QUAD 405 Evolution
September 2011

QUAD 405 Schematic as published in Wireless World Dec.1975
to support the article "Current Dumping Audio Amplifier"
by P J Walker of the Acoustic Manufacturing Co. Ltd. (Q.U.A.D.)

Revision: 6	keith@snook.eu	Page Size: A4
QUAD 405 - DCD Mod-3		
Sept 2011	Drawn: K. Snook	Checked:
		Page 1 of 1

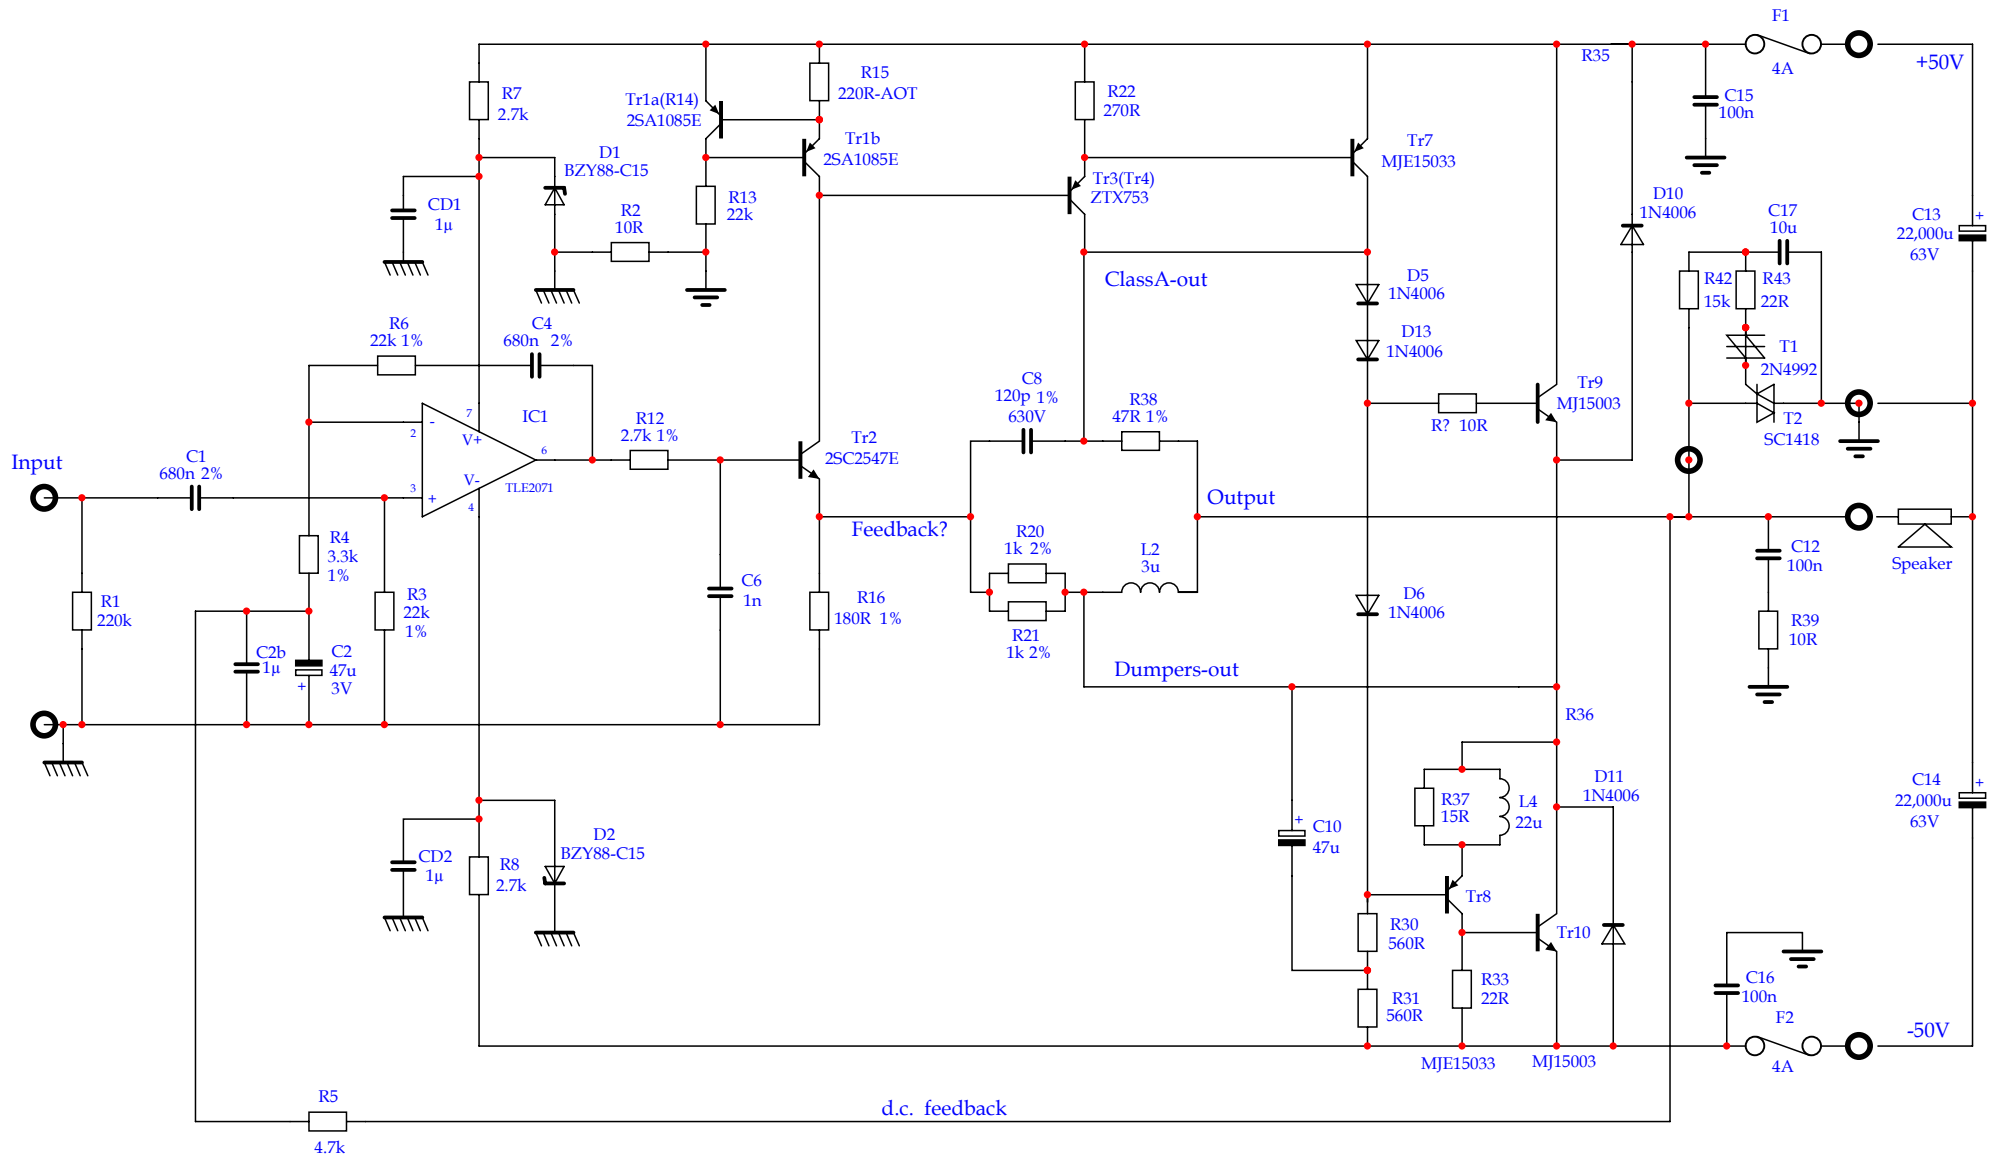
Components marked in green are changes or additions to the original n.f. = not fitted and Link = remove and wire across.

For original sensitivity 0.5V for 100W fit R4 = 1.6k and C2 = 100uF

For sensitivity of 1.5V for 100W fit R4 = 4.7k and C2 = 33uF

Tr3 should be bypassed base-emitter as shown and it should then be possible to safely remove C19 fitted across Tr10 collector-base on the solder side of the PCB - If you are not sure bypass Tr3 and leave C19

Components marked in grey with blue reference designators may be removed to disable current limiting - This should be done with caution and preferably after Tr9 and Tr10 are changed to higher power devices like MJ15003

This point was originally a bolt in the heatsink - Remove bolt and run a wire to 0V speaker terminal from R23

C19 can be removed if Tr3 is bypassed but if you cannot check for stability leave it in place

Note the 2 different ground symbols either side of R2 - probably to prevent internal hum loops - The input ground connects to the chassis at the input DIN socket and originally the other side of R2 connects to chassis via the bolt in the heatsink - Even if you do not provide a formal ground wire to the 0V speaker terminal as I show you should ensure that both sides of R2 are at the same potential - If one ground is missing the voltage at the speaker terminals will be about 20mV if both grounds are in place it should be less than 1mV - Both grounds should be connected to chassis

Revision: 3	keith@snook.eu	Page Size: A4
<h1>M12368 PCBs to DCD Mod-3</h1>		
1 Sept 2008	Drawn: K. Snook	Checked:
		Page 1 of 1

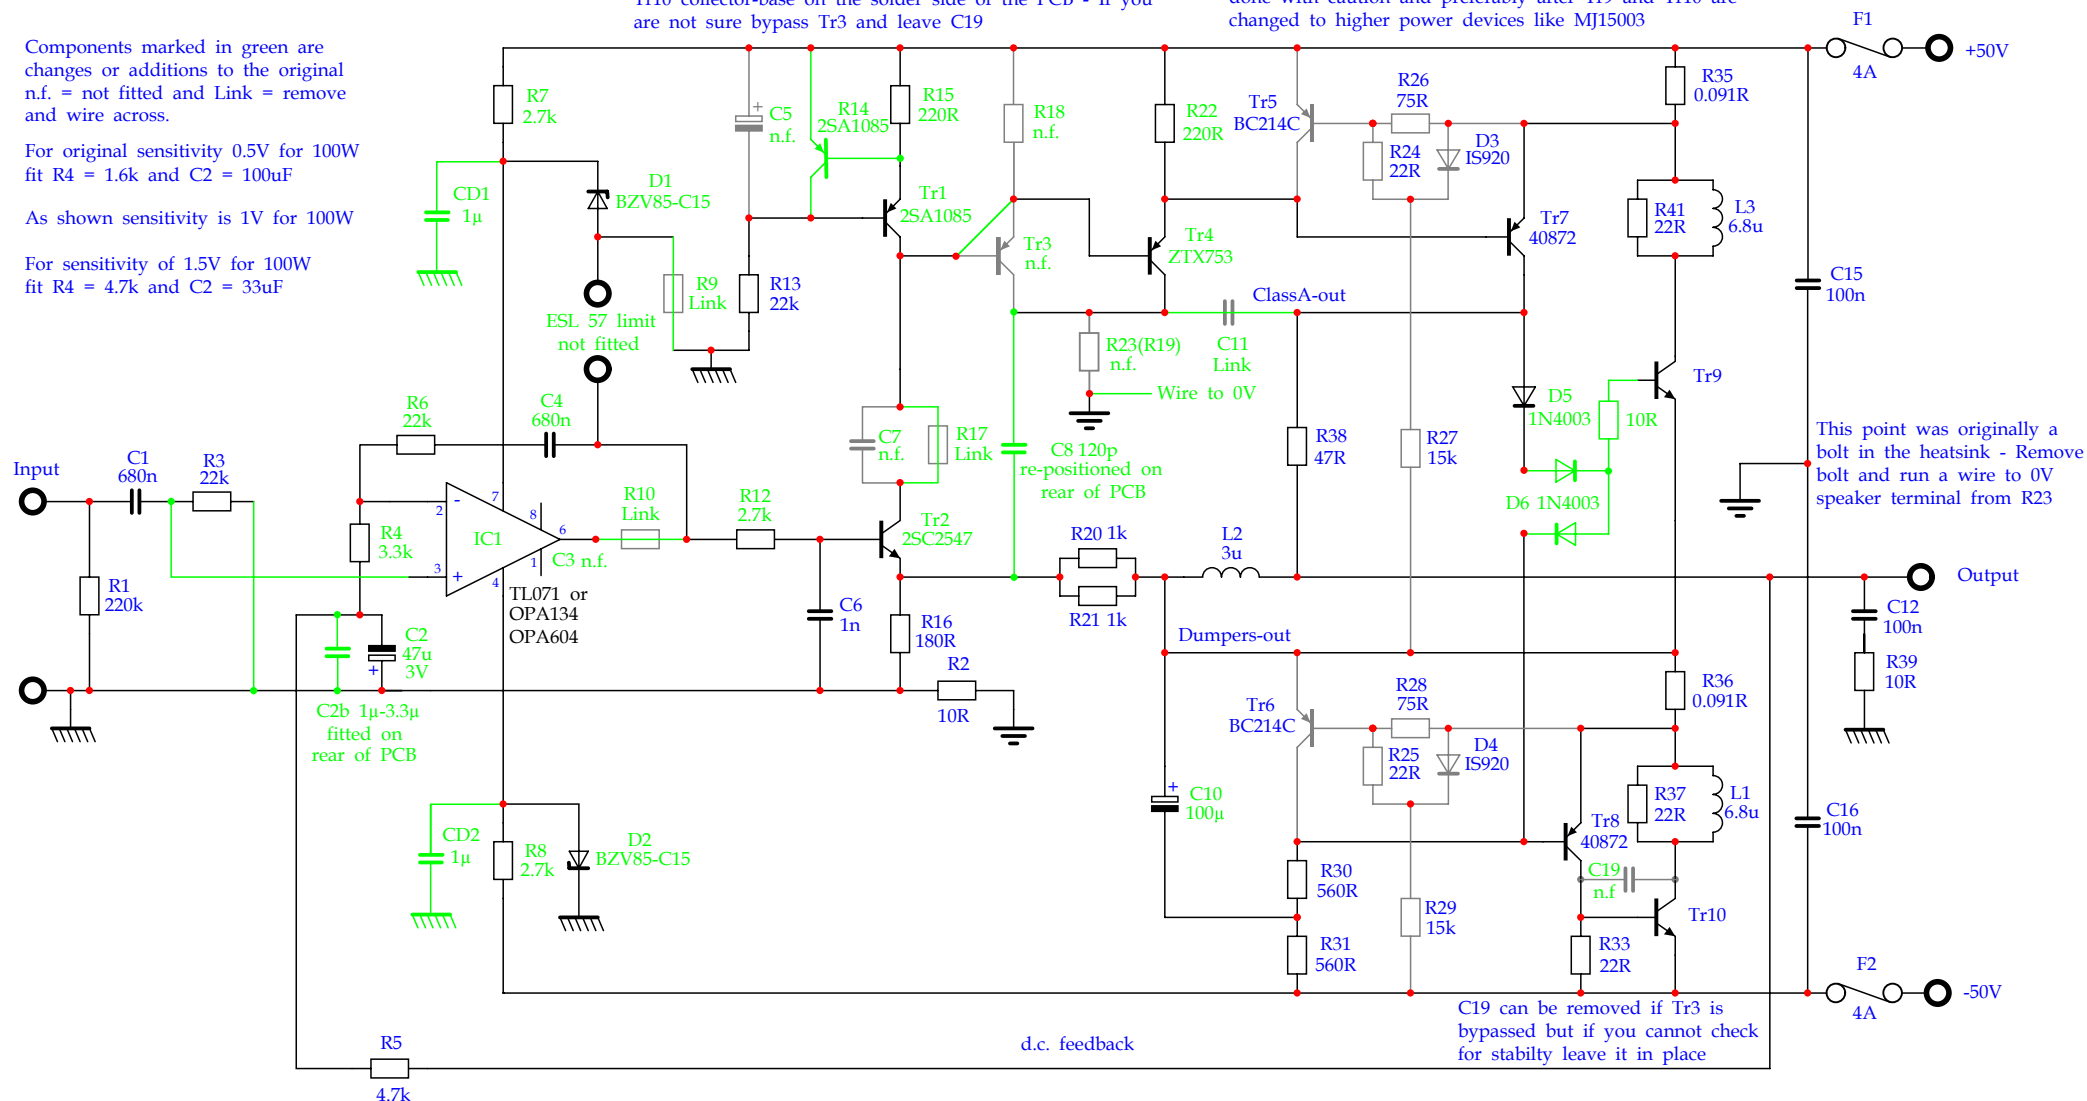
Note: This is only a schematic - It has been implemented as a mod to 12368 iss.10 and 12565 iss.7 PCBs but the circuit can oscillate at VHF radio frequencies which do not appear at the output but can put the transistors in compression - increasing the distortion and dissipation

Revision: 2	keith@snook.eu	Page Size: A4
QUAD 405 - DCD Mod-4		
19 Mar 2005	Drawn: K. Snook	Checked:
		Page 1 of 1

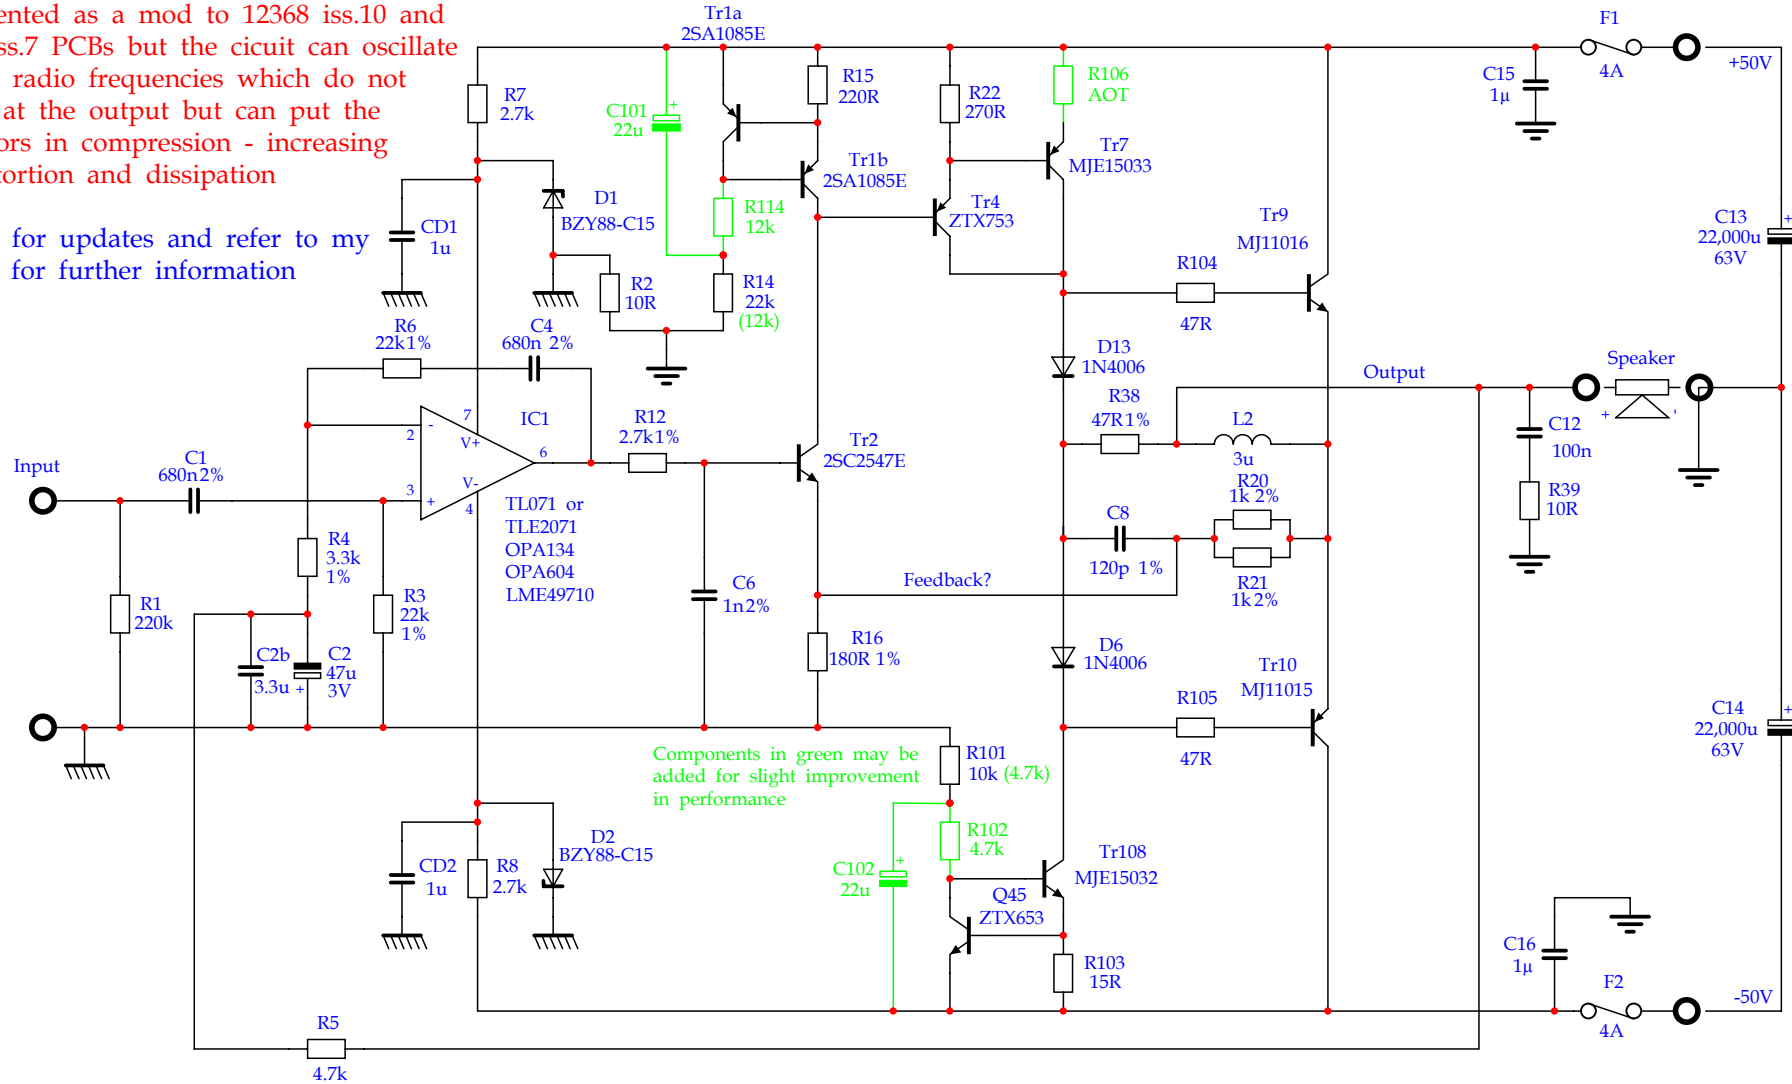
Components in green may be added for slight improvement in performance

Note: The "Current Dumpers" Tr9 and Tr10 are complimentary Darlington transistors – This layout WILL NOT work with low hfe output devices due to the base current required – The "Current Dumpers" can be made complimentary MOSFETs If D13 and D6 are changed for resistors but care must be taken to ensure that the Source-gate voltage can be obtained within the limits of Tr7 and Tr108 current drive
